DSI to HDMI Adapter

Errata Document

Errata #1: I2C address conflict with certain HDMI monitors

Affected Version: **[01521000] DSI to HDMI Adapter V1.0A**

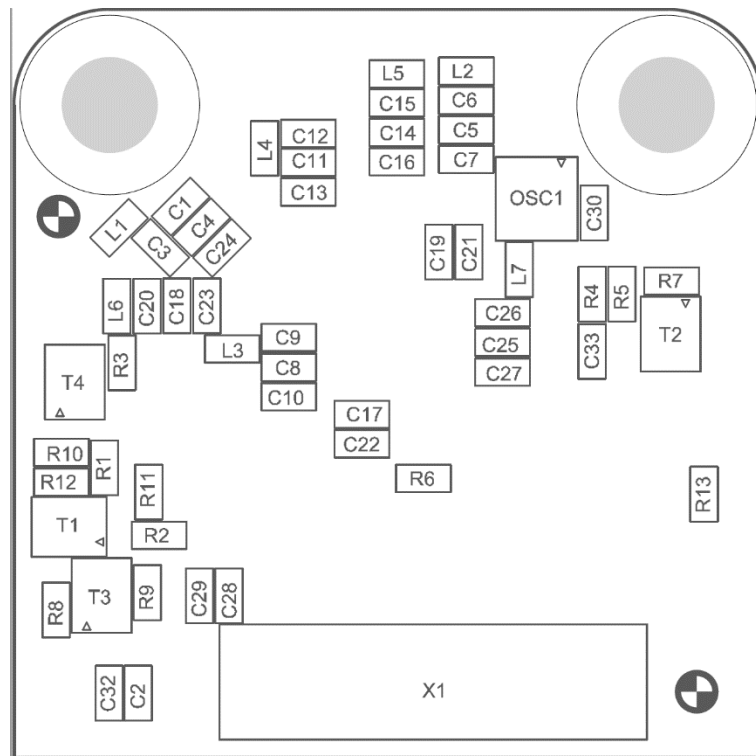
I2C address conflict with certain HDMI monitors caused that adapter does not work with the 4.14.78 BSP. Not connecting the DDC I2C channel resolves the issue.

Unsoldering T3 on the adapter, resolves the issue by disconnecting the monitor's DDC channel.
